STAFF RECOMMENDATION

1707 Holly Street

Application: New Construction—Addition; Partial Demolition

Description of Project: Application is to demolish an existing rear addition and to construct a new rear addition that extends wider on the left side and includes a ridge raise.

PROPOSED SITE PLAN

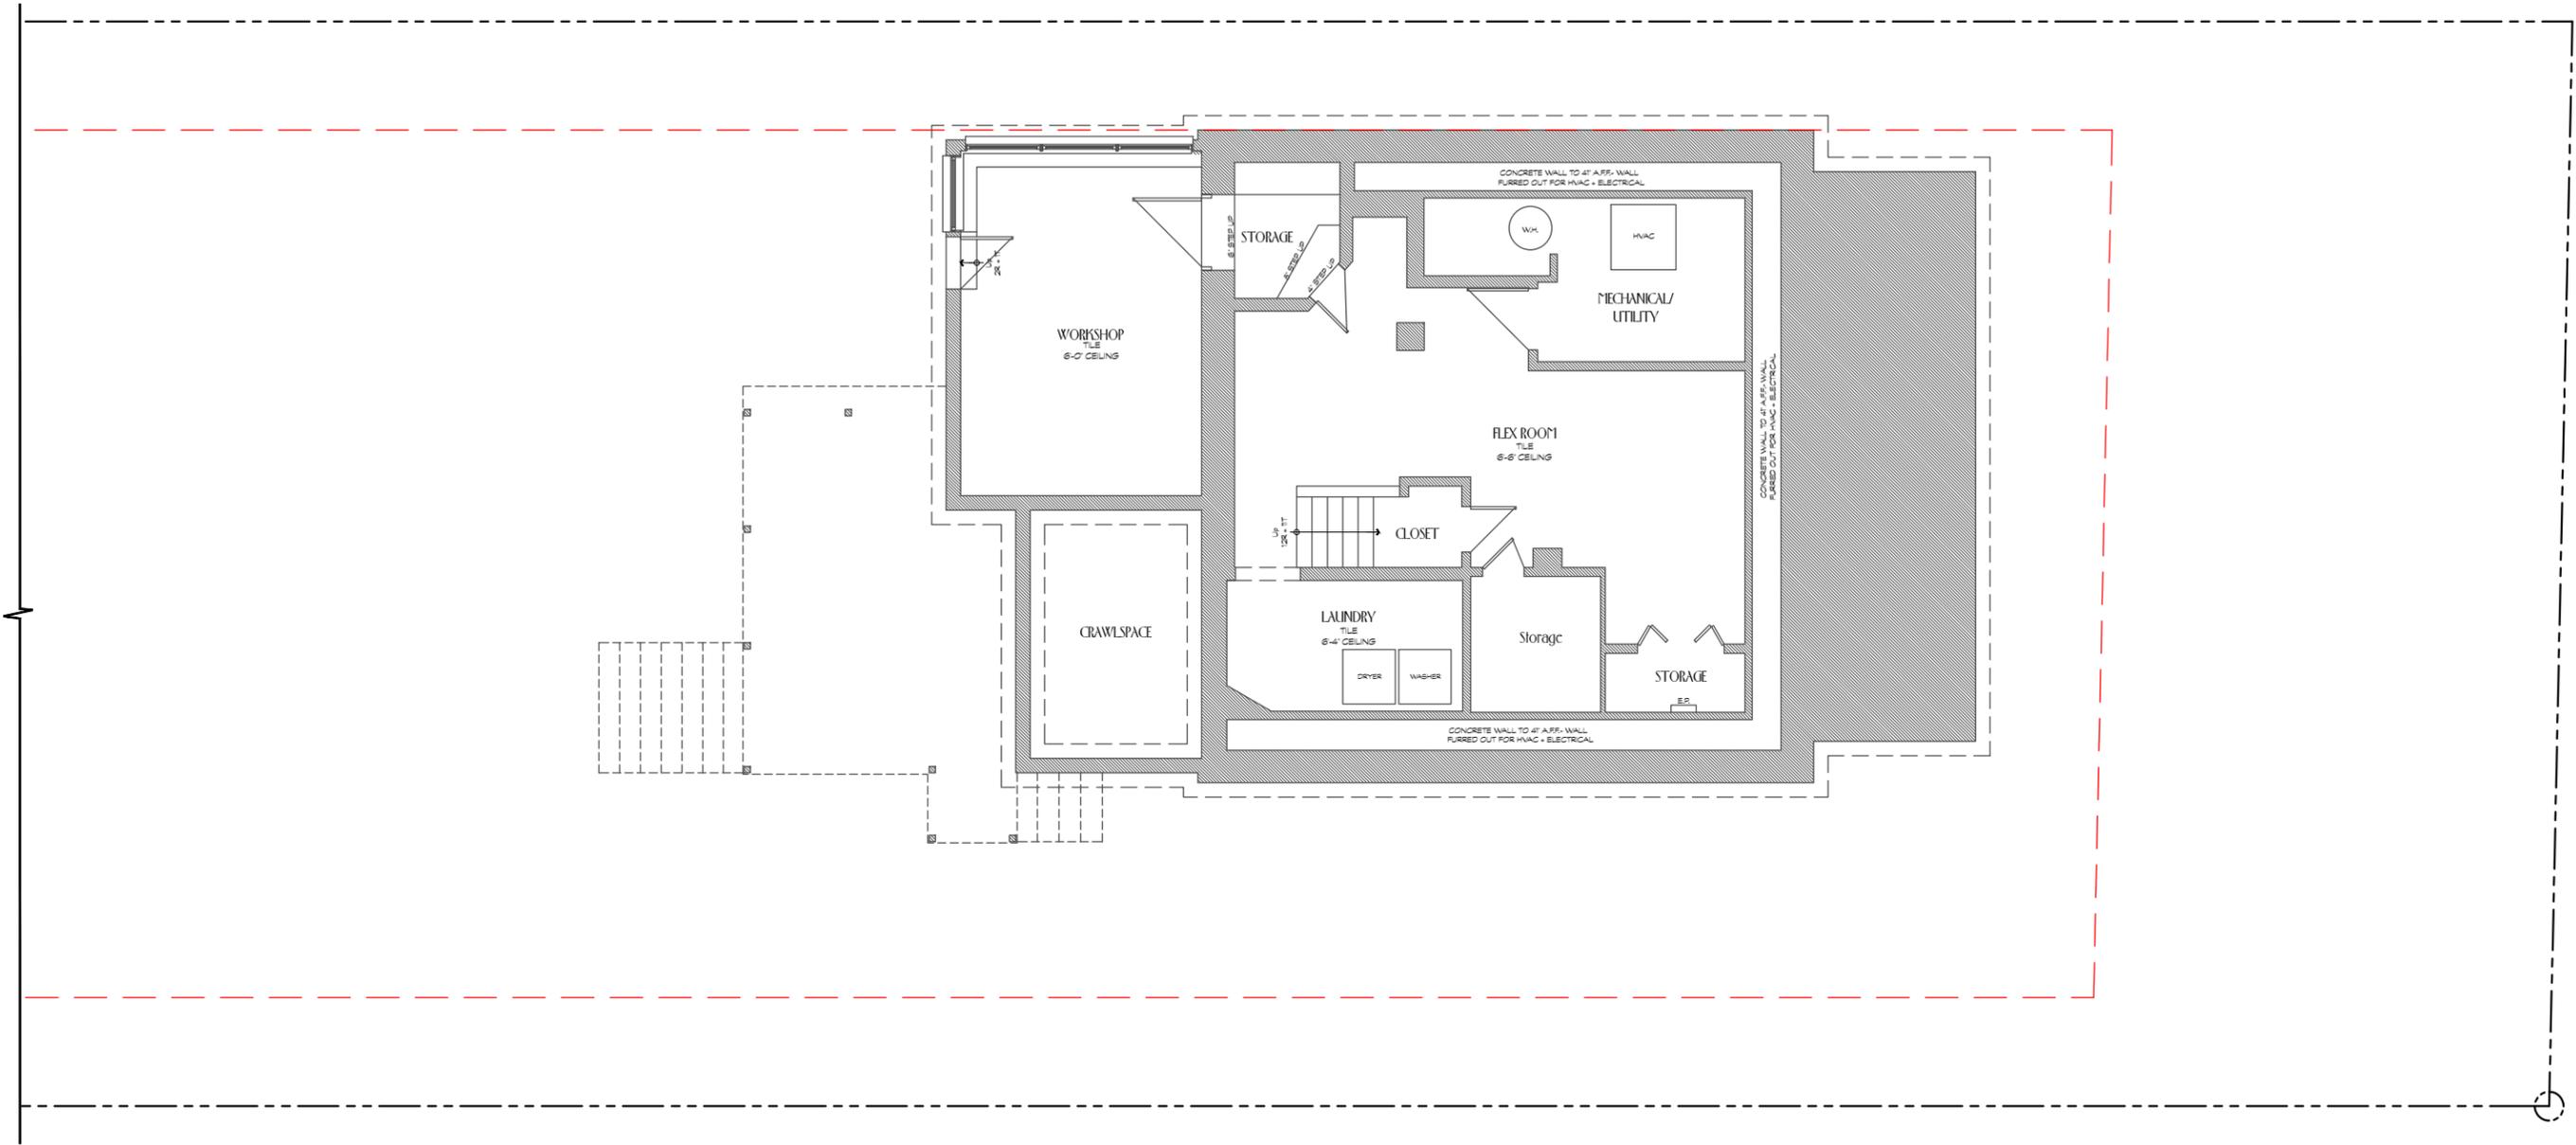
The proposed rear addition does not more than double the existing footprint and depth of the house. The addition is set in two feet (2') from both rear corners, in accordance with the design guidelines, and goes back twelve feet (12') on both sides before coming back out to match the width of the historic house on the right side and extend approximately nine feet, four inches (9'-4") wider on the left side.

Setback & Rhythm of Spacing: The addition meets all base zoning setback as it will be located five feet (5') from both side property lines and approximately forty-nine feet (49') from the rear property line. The rear of the addition will be located twenty-six feet, three inches (26'-3") from the existing outbuilding.

PROPOSED REAR ELEVATION

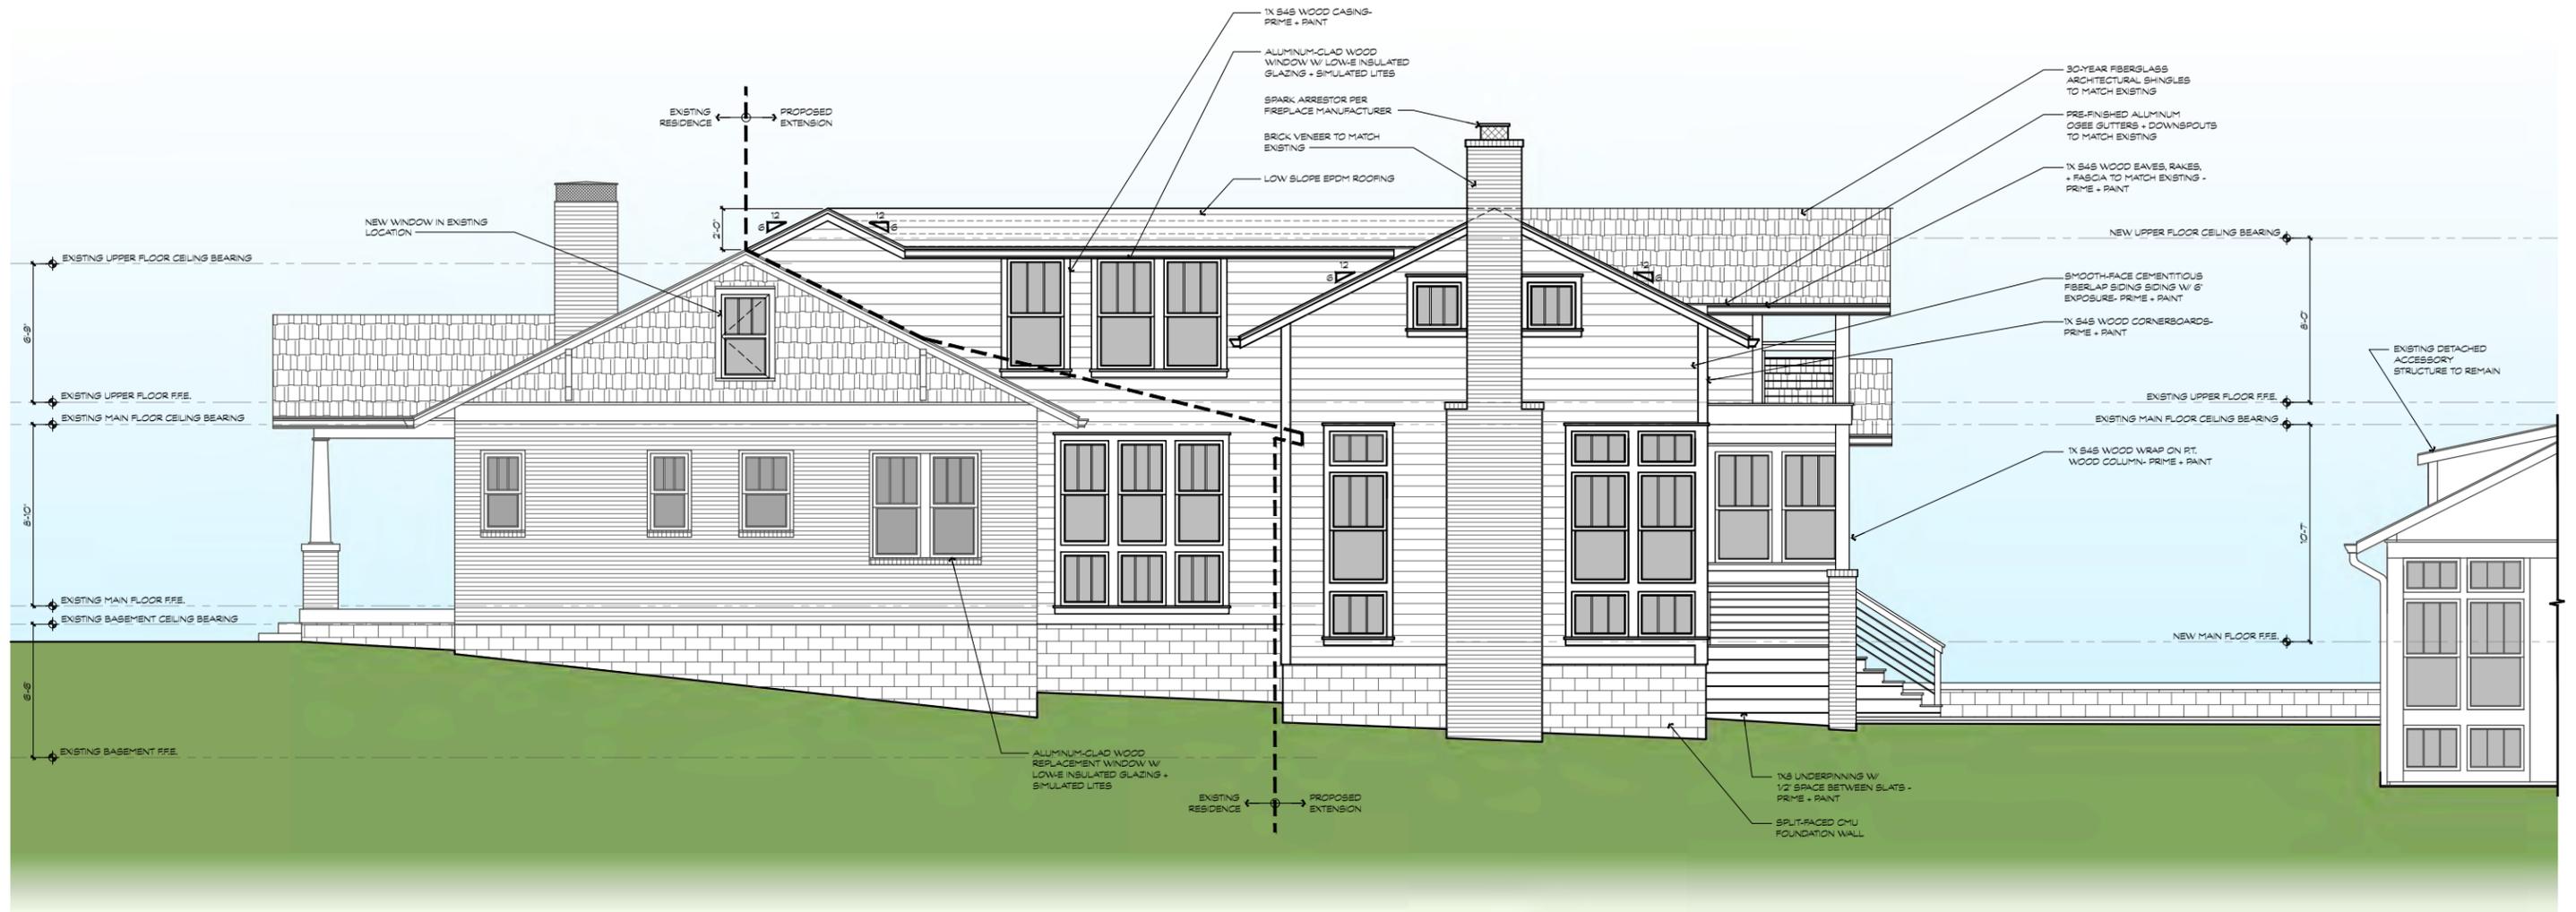
Roof form: The addition has a cross-gable form with a primary roof pitch of 6/12, which is compatible with the historic house. A lower sloped membrane roof that has 0.5/12 pitch ties into the ridge raise. While the design guidelines recommend a minimum pitch of 6/12, staff finds that the lower pitched portion can be appropriate since it is set in three feet, four inches (3'-4") from the eaves of the historic house on both sides. Given the inset, staff finds that the flatter roof will not likely be seen from the street.

Proportion and Rhythm of Openings: No changes to the window and door openings on the existing house were indicated on the plans. The windows on the proposed addition are all generally twice as tall as they are wide, thereby meeting the historic proportions of openings. There are some smaller square windows, but they are all located beyond the midpoint so are unlikely to be highly visible. There are no large expanses of wall space without a window or door opening.

**PROPOSED SIDE
ELEVATION**

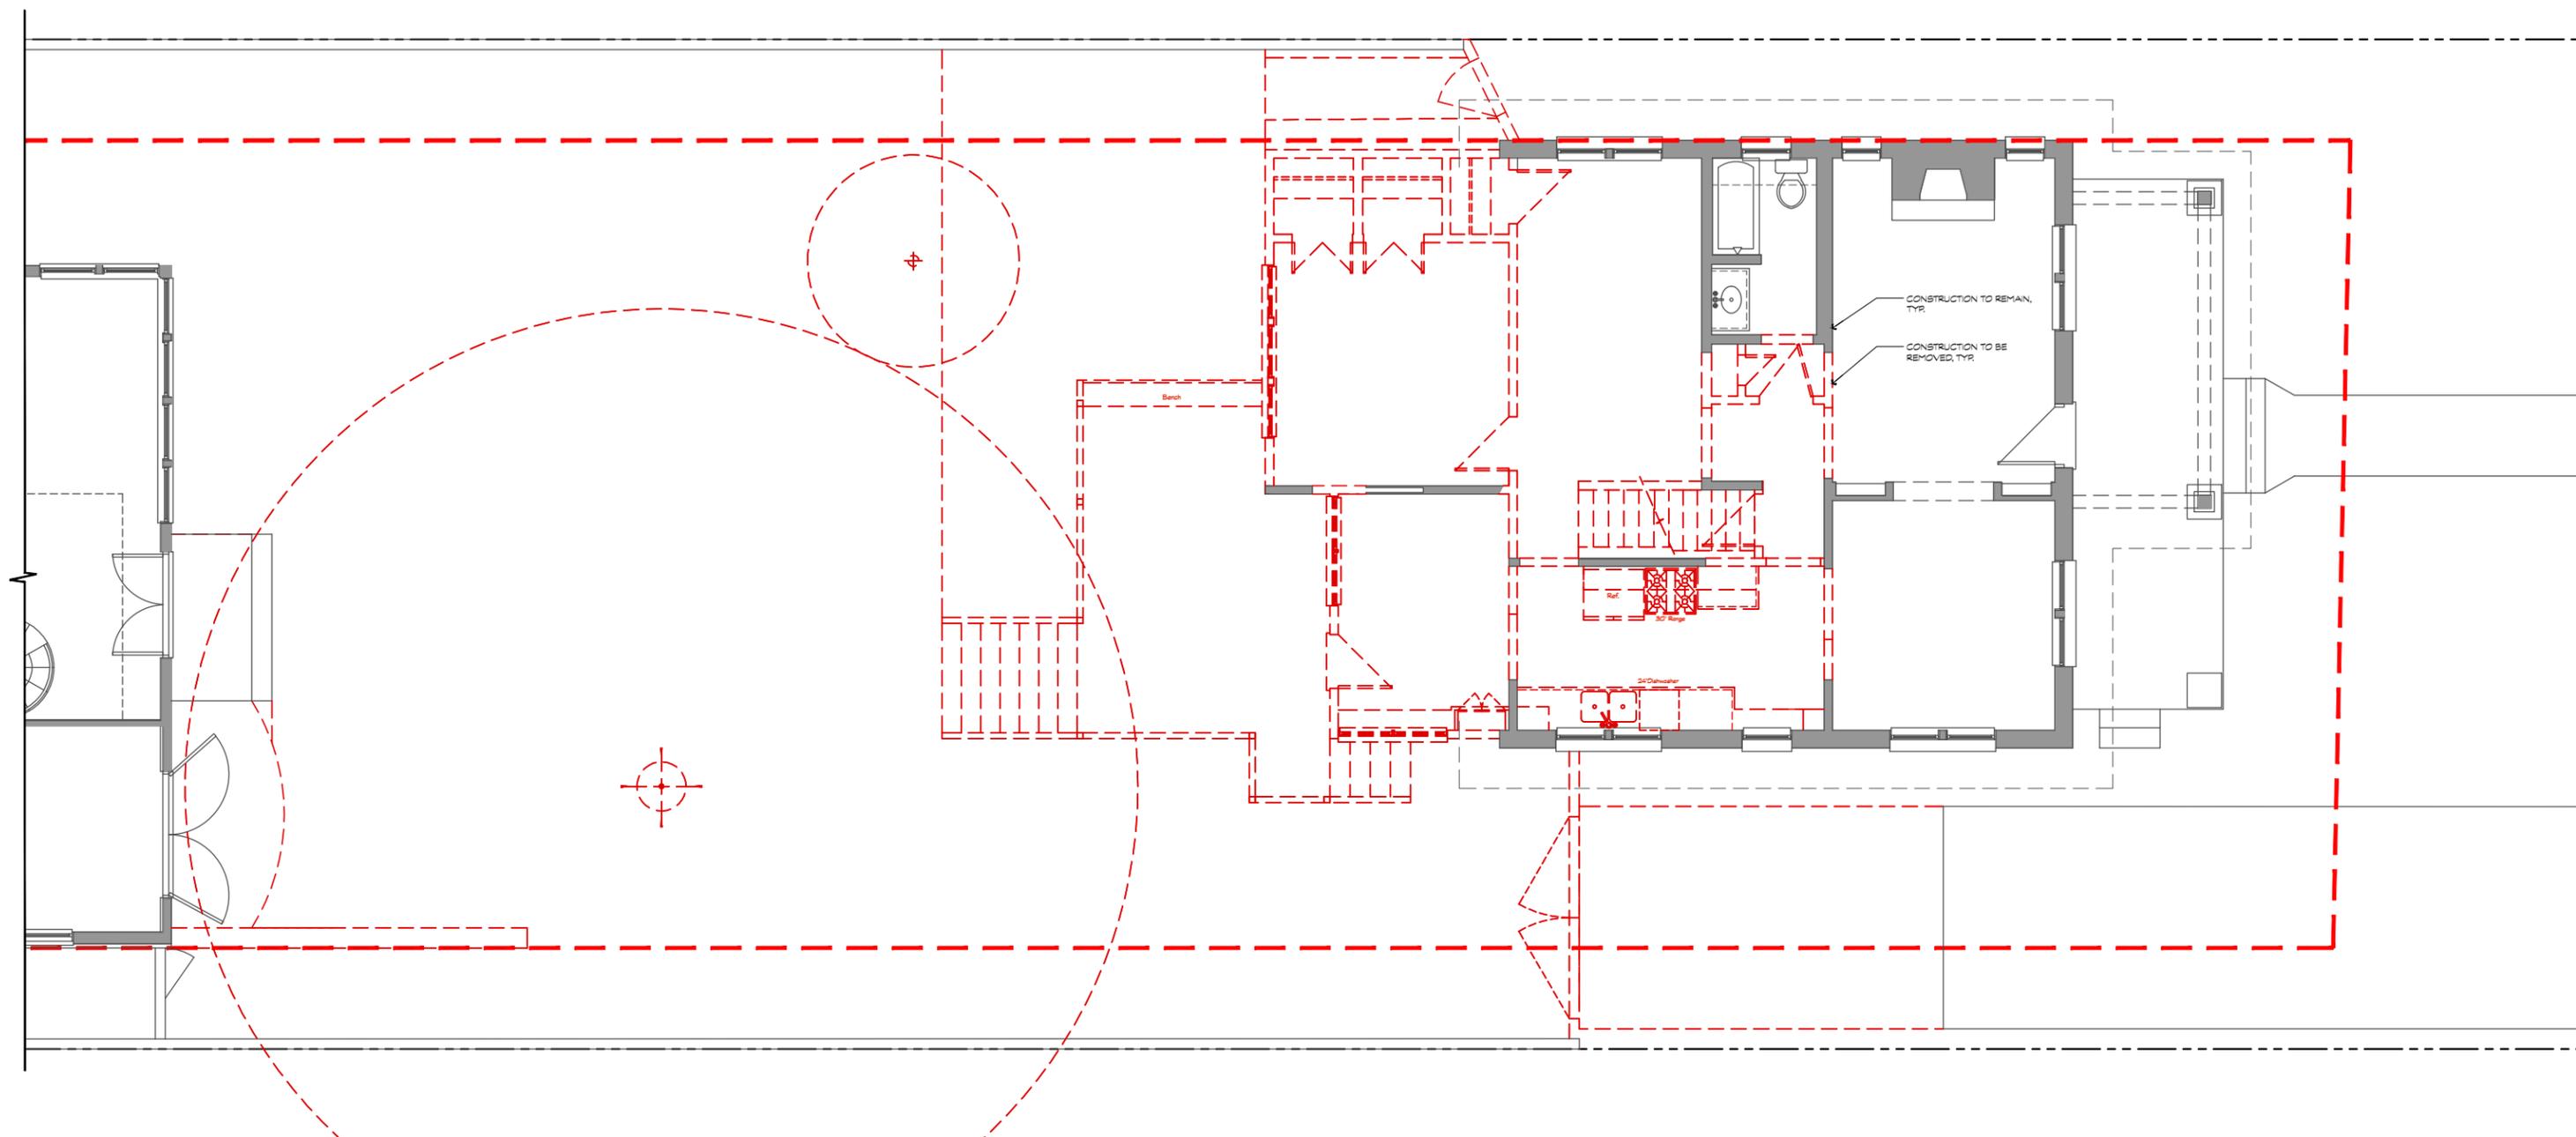
The plan notes that the siding is to have a reveal of six inches (6"). For the material to meet the design guidelines, the siding should have a maximum reveal of five inches (5"); the applicant has agreed to this. In addition, the final selections of the masonry, windows, doors, and membrane roofing color must be approved prior to purchase and installation.

1. The siding shall have a maximum reveal of five inches (5");
2. Staff approve the final details, dimensions and materials of windows, doors, and membrane roofing color prior to purchase and installation;
3. The HVAC shall be located behind the house or on either side, beyond the mid-point of the house; and
4. Staff approve the roof color and masonry color, dimensions and texture.
